Product Change Notice

Issue Date: September 23, 2019

Add ASE Taiwan as Bump supplier

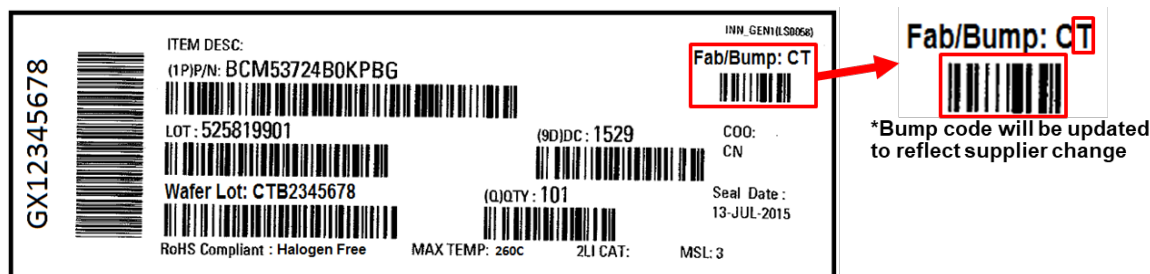
Additional CuP Bump supplier - ASE TAIWAN

- Adding bump supplier. Broadcom reserves the right to manage supplier.
- The construction of the bump is identical
- SPIL Taiwan has internally qualified the direct CuP bumping and in volume production.
